**Subject: Supplement to Notification of Class 1 Permit Modification Construction Updates for the Technical Area 63 Transuranic Waste Facility Container Storage Unit, Los Alamos National Laboratory, Hazardous Waste Facility Permit, EPA ID # NM0890010515**

**Supplement -  
Class 1 Permit Modification  
Construction Updates for the  
Technical Area 63 Transuranic Waste Facility  
Container Storage Unit,  
Los Alamos National Laboratory  
Hazardous Waste Facility Permit**

**EPC-DO-16-203**

**TA-63 TWF Concrete Pad As-Built Slopes**

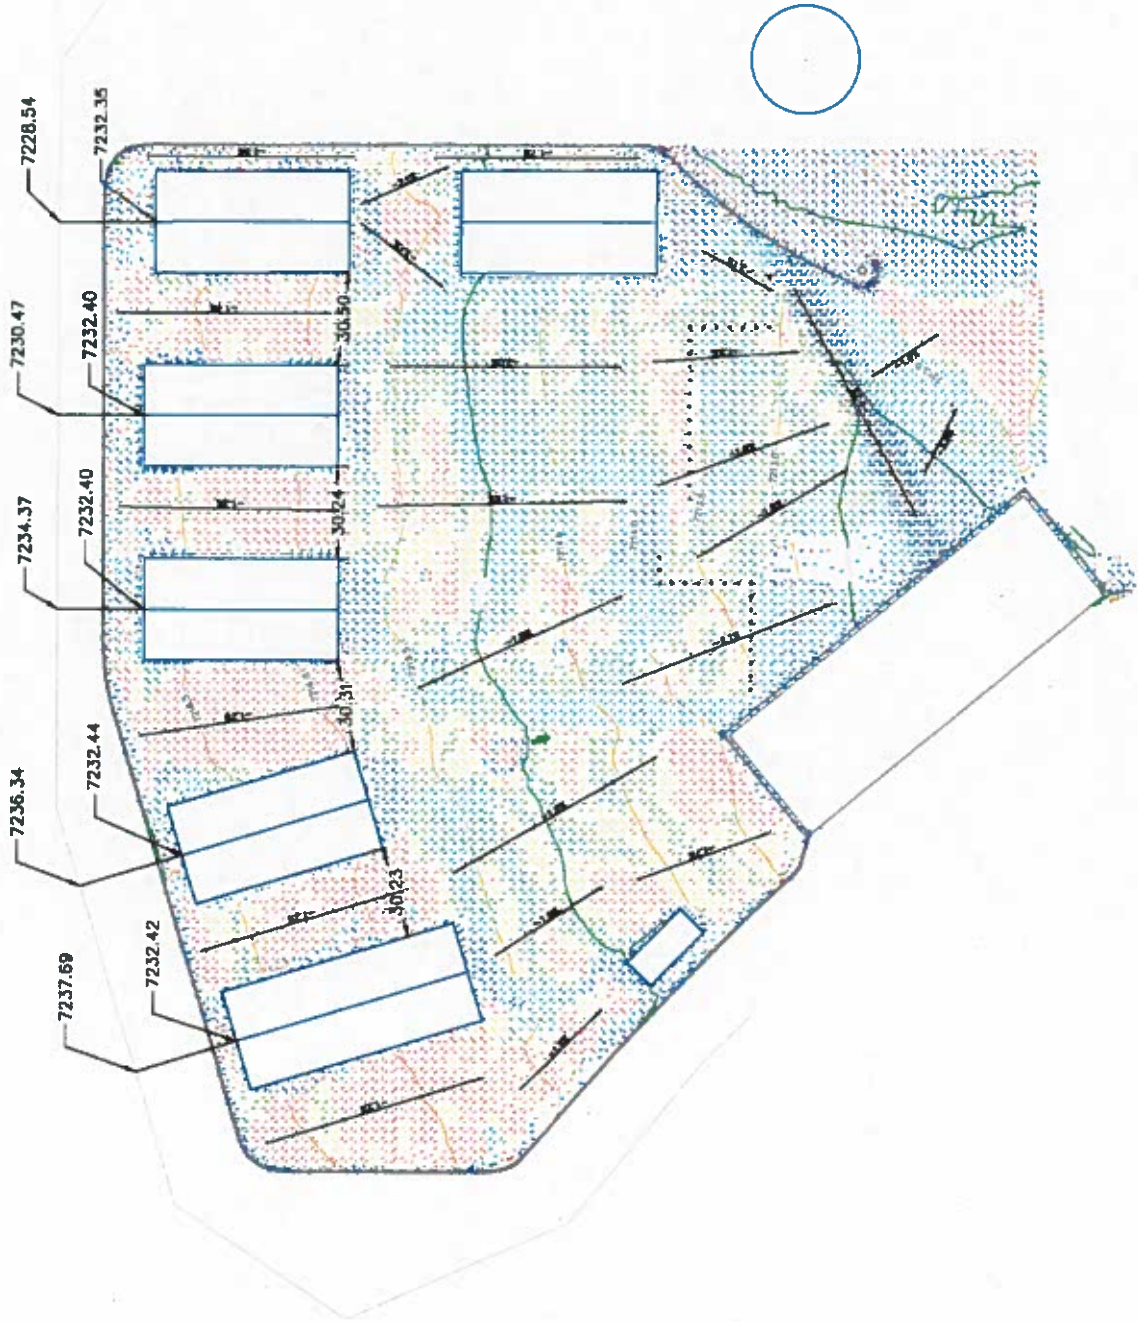
As included in Permit Attachment A, *Technical Area (TA)-Unit Descriptions*, Section A.6.1, *Concrete Pad*, Section A.6.5, *Retention Basin*, and Section A.6.9, *Control of Run-On/Run-off*, the slope of the concrete pad directing run-off to the TA-63 TWF retention basin was described as nominally or approximately 2%. As constructed at the facility, the runoff slope of the concrete pad is not constant due to the need to contour the areas between the boundaries of the pad and the storage buildings while maintaining a sufficient slope to direct runoff to the retention basin. Due to this factor, the range of slopes present at the site expressed in percentages is varied and the 2% criteria given in the text also represents an inaccurate bounding value. As such, the description in the permit is no longer correct. Therefore, the affected sections of the facility description have been revised to replace the description with a range of percentages for the concrete pad slopes. As shown in the figure in Attachment 2 of this submittal, these slopes vary from 1.1% to 2.5%. This range has been added to the permit description. This permit revision

**Attachment 2**  
**Permit Attachment A**  
**Facility Area Description Revisions**  
**Figure: TA-63 TWF Concrete Pad As-Built Slopes**

- Section A.6.1, *Concrete Pad*, states that “The pad is sloped at an approximate 2% grade to promote drainage of storm water and potential fire suppression water to the retention pond...” This has been altered to read “The pad is sloped in a range from 1.1% to 2.5% to drain storm water and potential fire suppression water to the retention pond...”

- Section A.6.5 *Retention Basin*, contains a statement that “The retention basin is designed to collect surface storm water or melt water run-off from the concrete pavement via the slope (nominally 2%) of the concrete pad...” This sentence has been revised by deleting the parenthetical phrase “nominally 2%” and replacing it with the phrase “ranging from 1.1% to 2.5%.”

- Section A.6.9 *Control of Run-On/Run-off*, states that “The TWF site slopes nominally at a 2% grade to promote drainage to the retention pond.” This sentence has been replaced with “The concrete pad within the permitted unit at TWF is sloped in a range from 1.1% to 2.5% to drain storm water to the retention pond.”
